KINGSTON STEAM PLANT
 ASH DISPOSAL AREA DIKES RAISING
 SOILS INVESTIGATION REPORT
 DATED 11/3/75 AND EVALUATION OF REPORT
 (CDB RECORD COPY)

Kingston Steam Plant - Ash Disposal Area Dikes

Raising - Soils Investigation Report 11/3/75 and
Evaluation

KINGSTON STEAM PLANT - ASH DISPOSAL AREA DIKE RAISING - SOIL INVESTIGATION

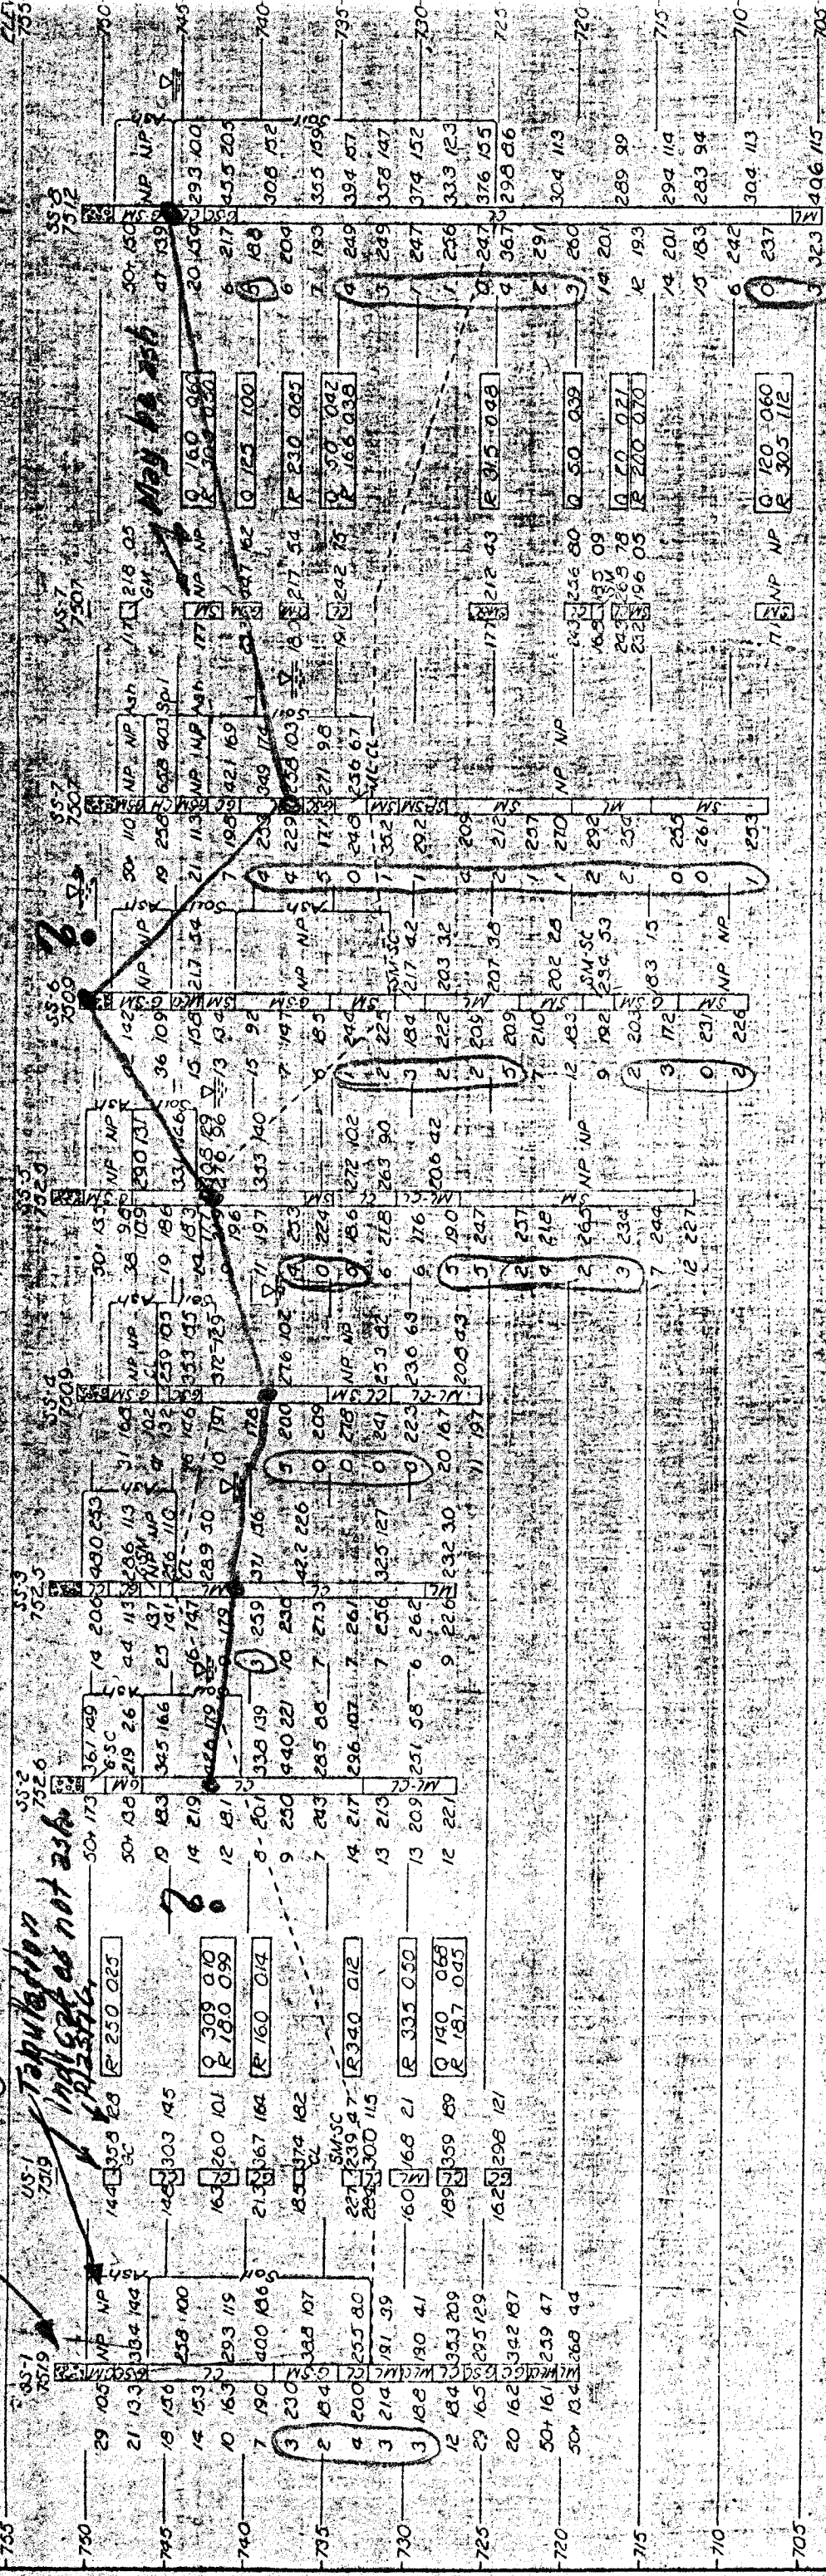
OLD DIKE

Top of dike 765'

Work was done on fill of dike
Under order to demolish
Dike need to remove on old dike
Boring 55 inside.

Tapulation
Indicated as not also
possible

Borings 1-0 are
old dike

SCALE: 1"=20'
 KINGSTON STEAM PLANT
 FOUNDATION INVESTIGATION
 BORINGS 15-0

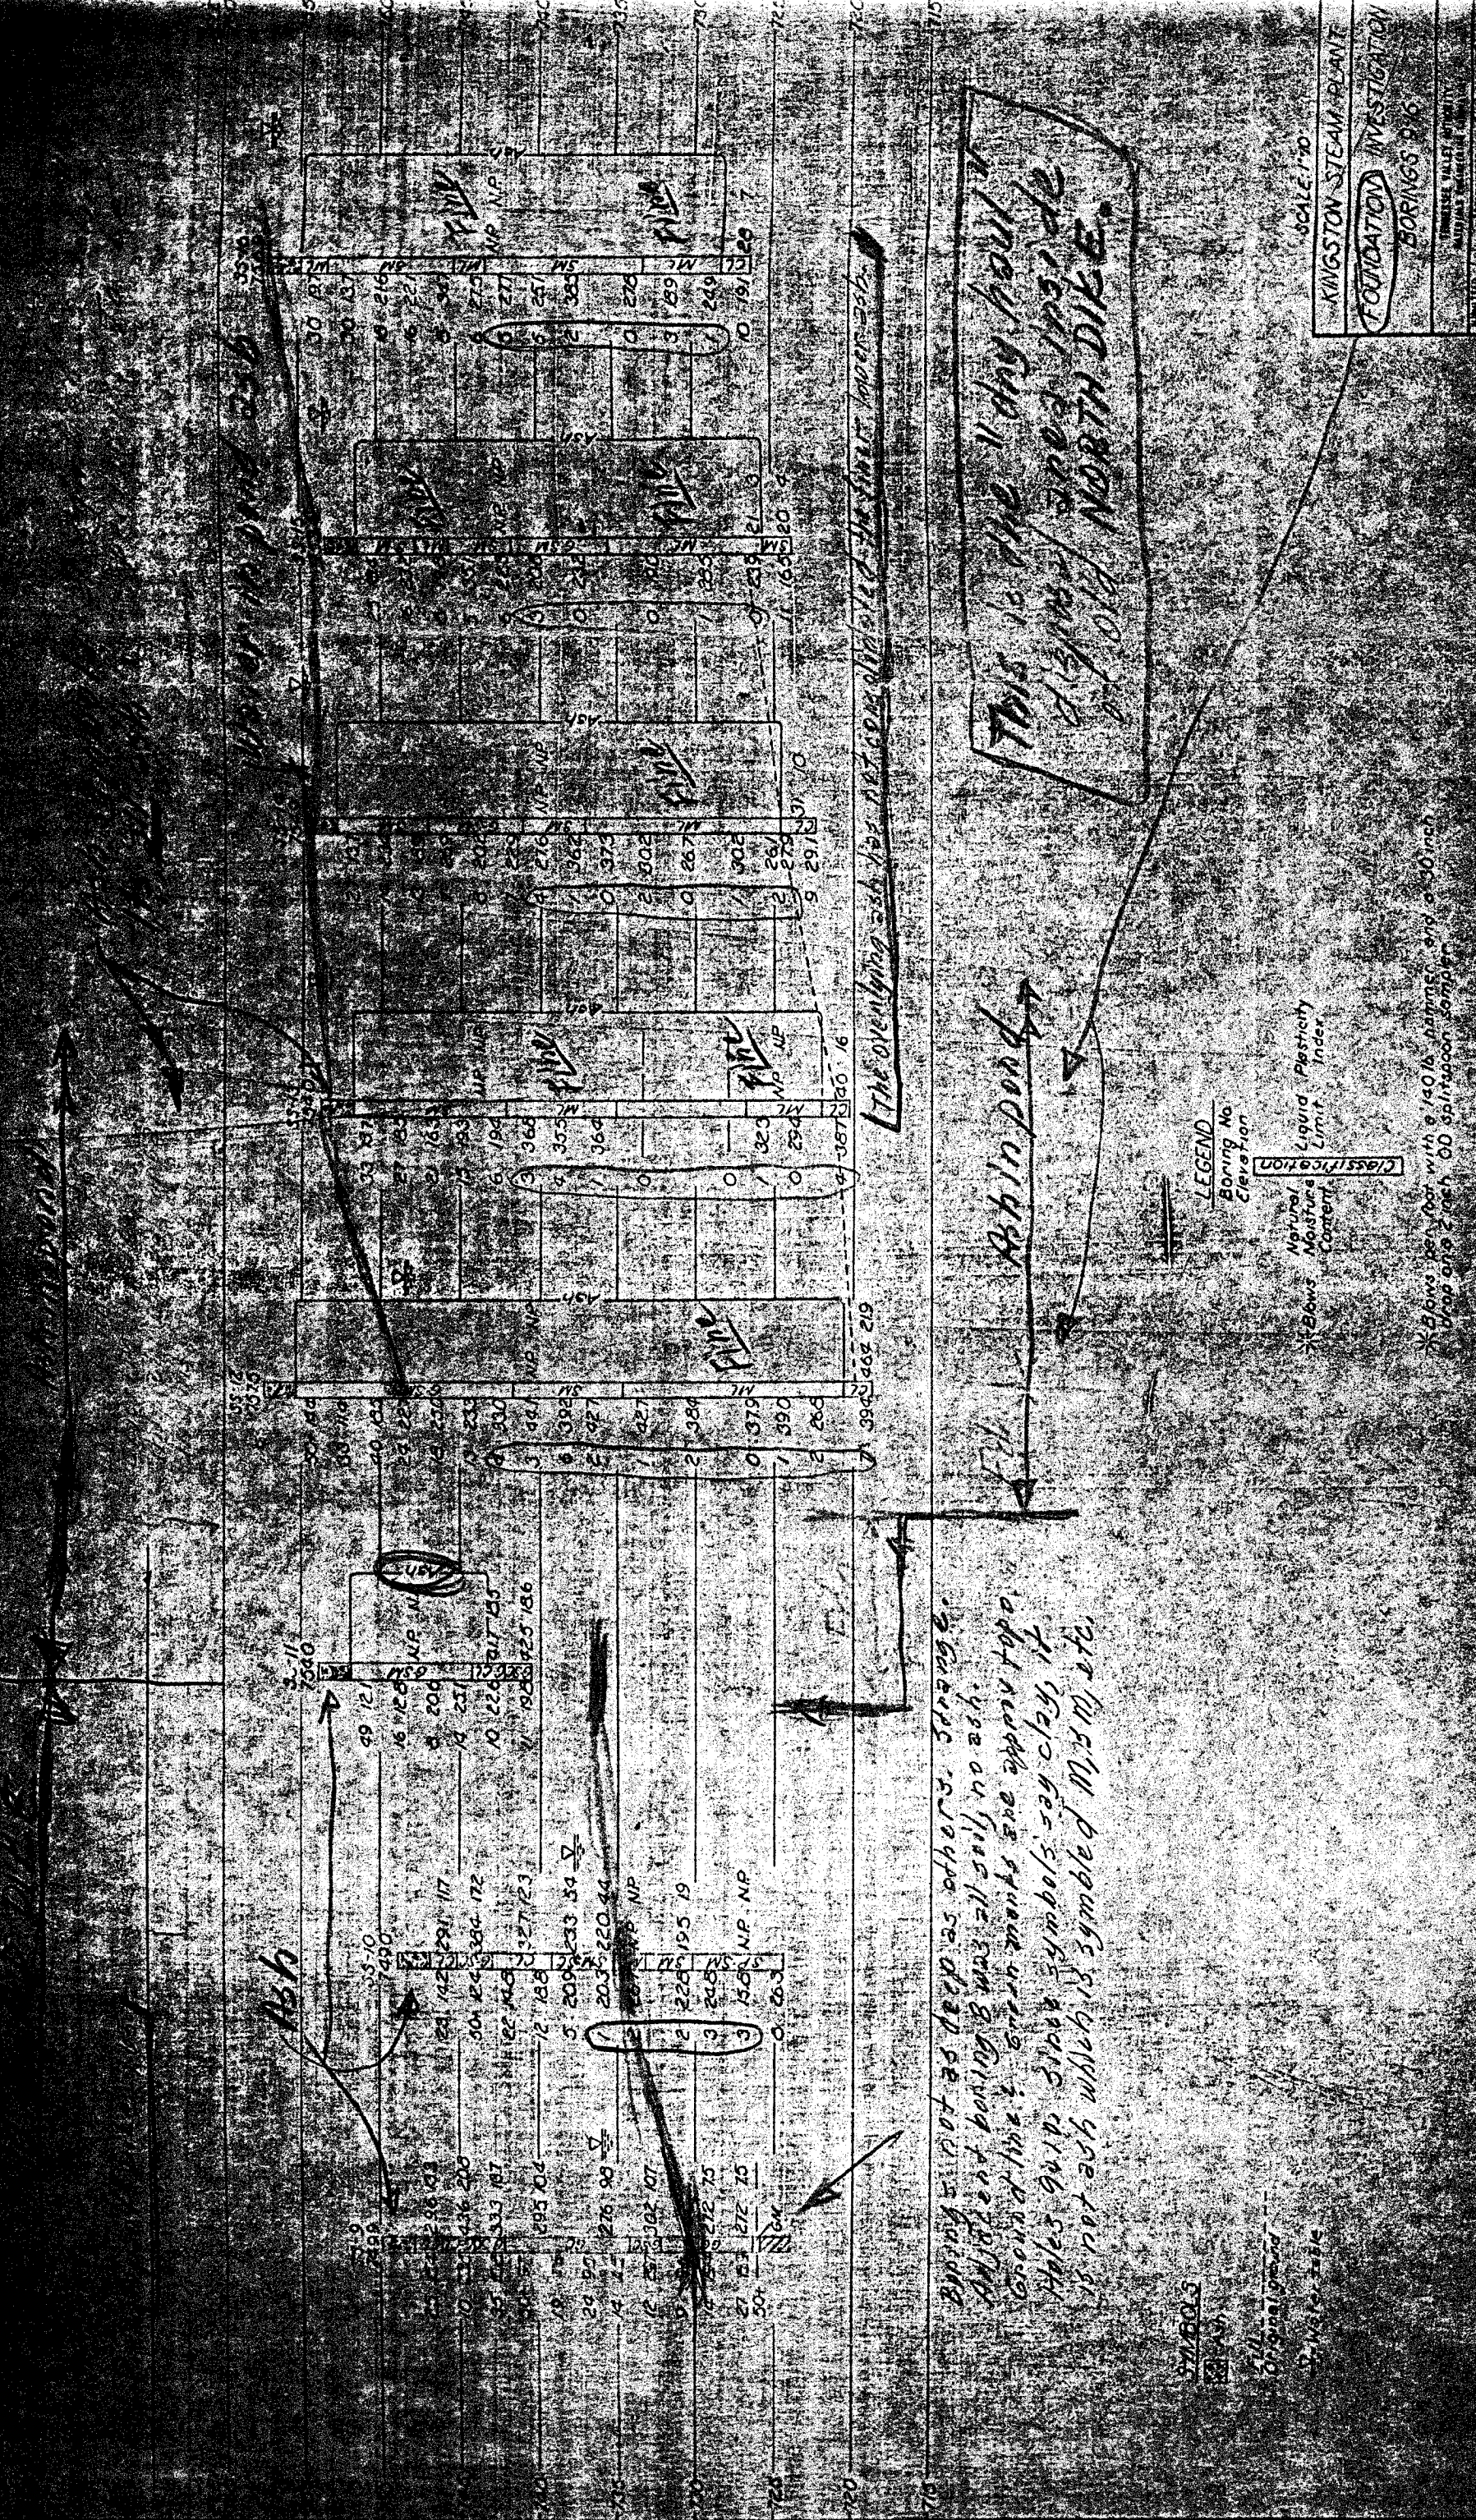
Ash in pond

The overlying ash has been deposited in pond

This is the "dry haul" deposit spread inside of old NORTH DIKE.

KINGSTON STEAM PLANT
 BORROW INVESTIGATION
 AREA A
 BORINGS 1-9
 TENNESSEE VALLEY AUTHORITY
 MATERIALS ENGINEERING LABORATORY
 SUBMITTED BY: [Signature]
 RECORDED BY: [Signature]
 DRAWN BY: [Signature]
 DATE: 10/17/75
 SHEET: 36 OF 37

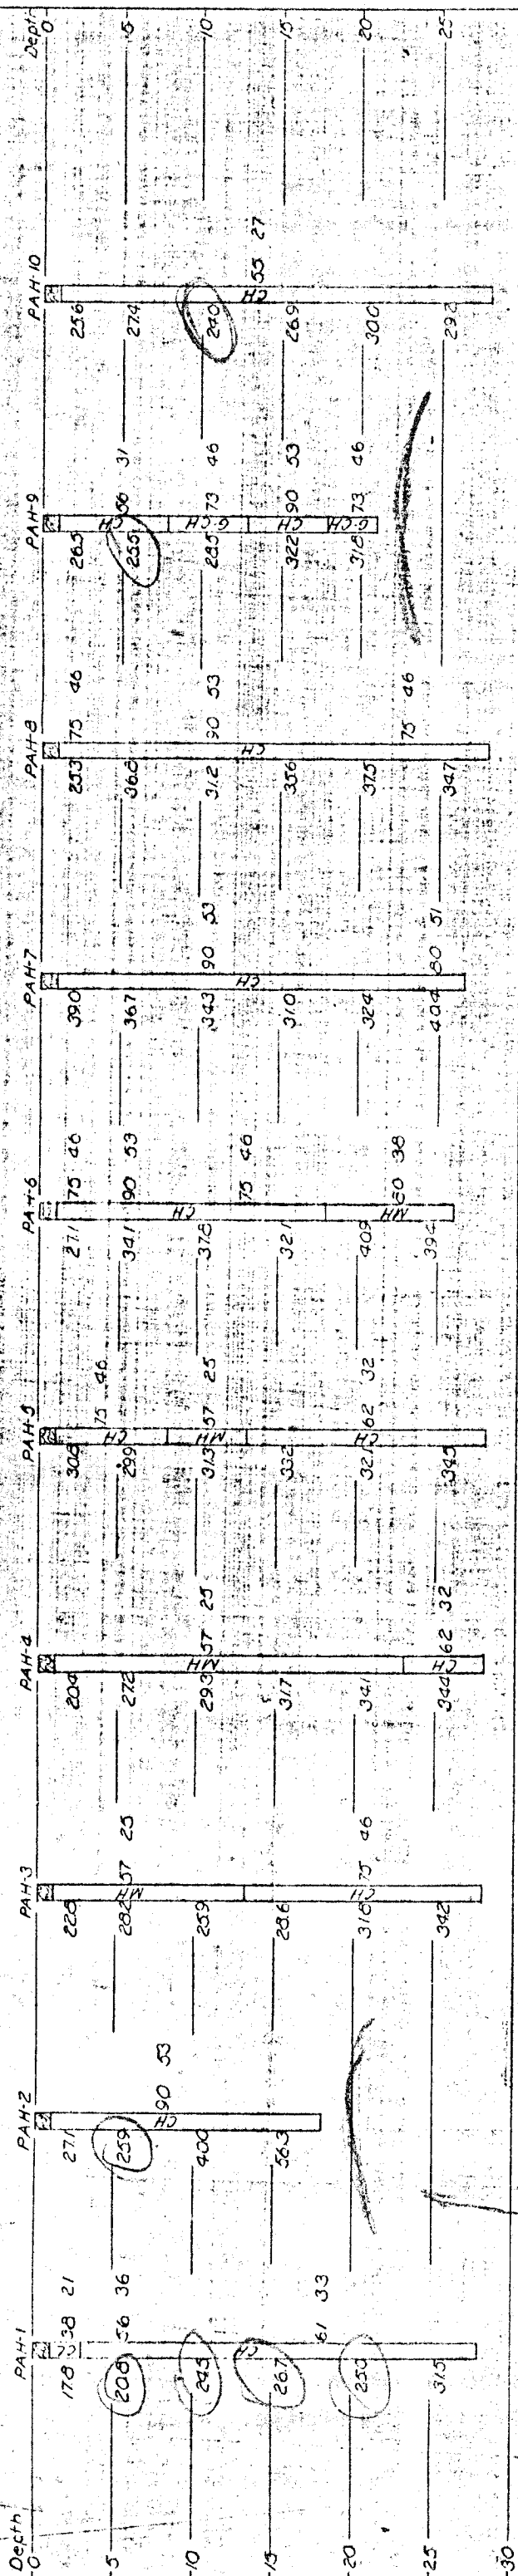
Plot 13 depth.
 No indication of top or high and low and effect on moisture. CL+CH so probably little effect anyway.

No obvious stratification in moisture content. Fairly good soil. Apparently generally drier than Areas B+C.

Groundwater in borrow area?

Classes III + IV CH
 Opt moisture 25 to 30.
 Classes I + II CL + sandy CH
 Opt moisture 20 to 22.
 Indicated also: Area A 15' plus to wet borrow.
 Area B 20' " " " " " " ?
 Area C, partly 10' " " " " " "

Phone with lab (Chilbines) 11/11/75
 Effort was not made to locate groundwater as such.
 The "high boring" was terminated when soil became obviously wet.

KINGSTON STEAM PLANT
FOUNDATION INVESTIGATION
BORINGS 17-24
TENNESSEE VALLEY AUTHORITY
METALLS ENGINEERING LABORATORY
MEMPHIS
INNOVATION
017 25 96 GS 3 604/100

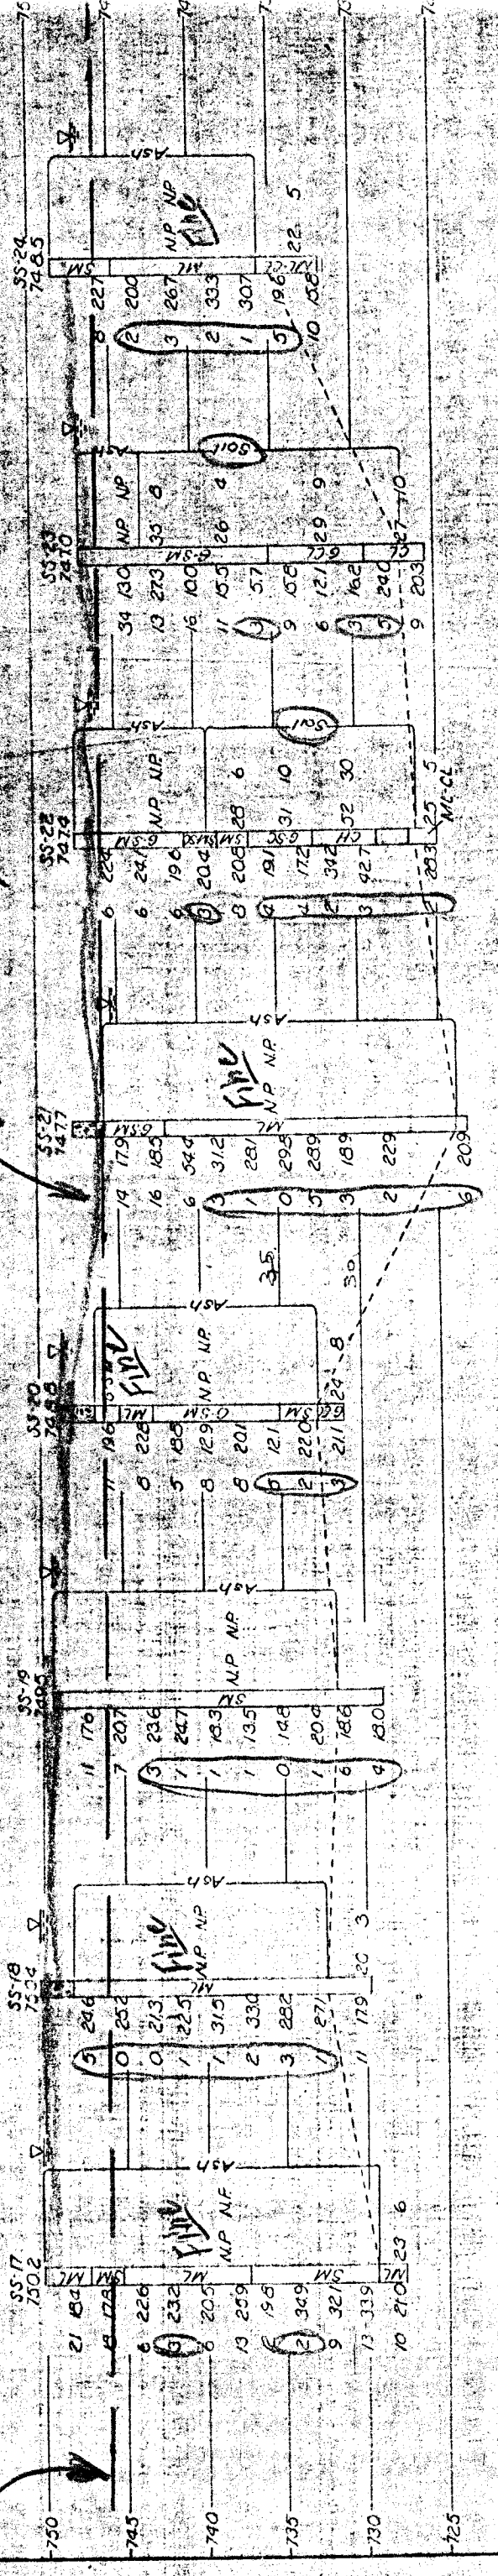
Ash inside
Old DIKE C

Ash inside
Old ROAD DIKE

Soil Request says borrow ash only above
E1 746. There is little. But request says take up for
density and strength in-situ. This was not done.

Water in pond ash.

These are borings
of ash in pond
along old DIKE C
and ROAD DIKE

Not foundations
Ash in pond.
